PLAN OF DEVELOPMENT

BCC DS
RECEIVED
 3/07/2026
 APPLICATION REF
 A007032858

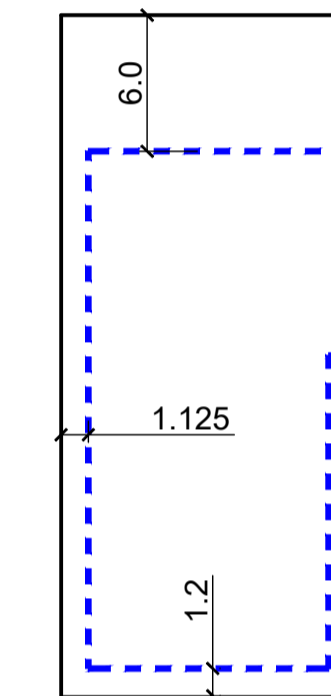
Provide easement in gross of 8.0 metre width and 10.3m length (at the southern frontage of Lot 9) to provide for a refuse turnaround area. A separate driveway crossover is to be provided to Lot 9 to ensure that the temporary turnaround area not obstructed under any circumstance.

1.0 metre wide easements within Lots 10 to 17 and Lot 20 for underground drainage and overland flow in favour of Council to suitably convey flows from the upslope catchment.

3.0m wide concrete maintenance driveway and access is to be provided to the drainage reserve Lot 900. Lock-rail to be provided in accordance with BSD-7054 Revision B. Detailed design outcomes of the maintenance access are to be confirmed as part of subsequent operational works applications.

Lot 800 and Lot 900 are to be transferred to Council as drainage reserve. Fence Log Barriers are to be provided along the frontages of Lot 800 and 900 to the New Road, and lockrails provided over maintenance access driveways; in accordance with BSD-7012 and BSD-7054.

Provide a 5.5m wide driveway crossover with 0.25m wide splays on either side extending into the rear lot accessway for a minimum length of 6.0m prior to tapering back at a 1:4 ratio to the width of 3.1m for the remainder of the rear lot access. The driveway is to allow for a vehicle to exit the roadway of Beams Road whilst another vehicle is queued to exit from the accessway.

Driveway to be setback a minimum of 1.2 m from the existing electrical pole
